INITIAL FIRE SAFETY INSPECTION REPORT

Jin Hong Garments Ltd.

RSC ID: 25943

Date: 22-Oct-2024

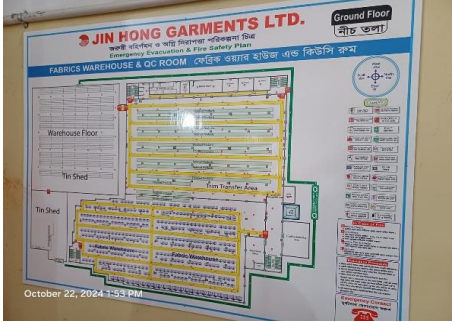
F-2	Means of Egress	<p>Uneven walking surface were found from exit discharge of Stair-4 and are not protected from slip or tripling hazard.</p> <p>Location: Building-1_North Side_Stiar-4</p>	<p>Provide an even level walking surface in exit discharge in accordance with 6.3.4 of RSC Technical Guidelines (Standard_V1.0)</p>	<p>Within 3 months</p>
-----	-----------------	---	---	------------------------

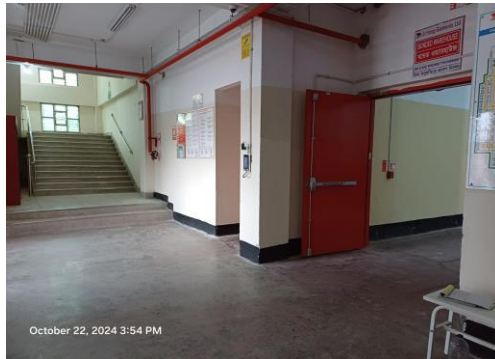
F-7	Means of Egress	<p>Storage room discharges directly into the exit stair enclosure.</p> <p>Location: Building-1_Ground Floor.</p>	<p>Openings from exit enclosure to storage spaces shall be provided with a vestibule with fire rated construction and openings. Provide a 1.5-hr. fire rated door on the exit stair side and a 1-hr. fire rated door on the storage room side as per 6.14.3-RSC Technical Guidelines Standard V1.0.</p> <p>Ensure that the fire rating of the vestibule construction matches that of the exit stair enclosure.</p>	Within 3 months
-----	-----------------	---	--	-----------------

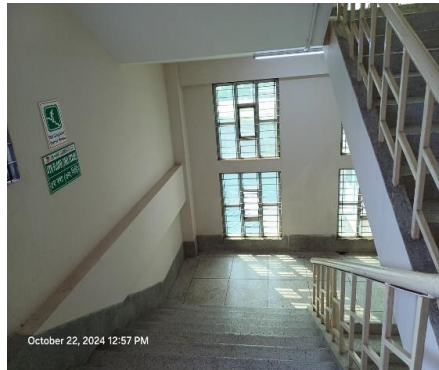
F-8	Means of Egress	<p>Aisles has not been found in several locations and some of the aisles were found less than 36" in several location.</p> <p>Location: Building-1, Shed-1</p>	<p>Aisles shall be provided at all required places and the minimum unobstructed clear-width of aisles is 0.9 m (36 in.).</p>	<p>Within 3 months</p>
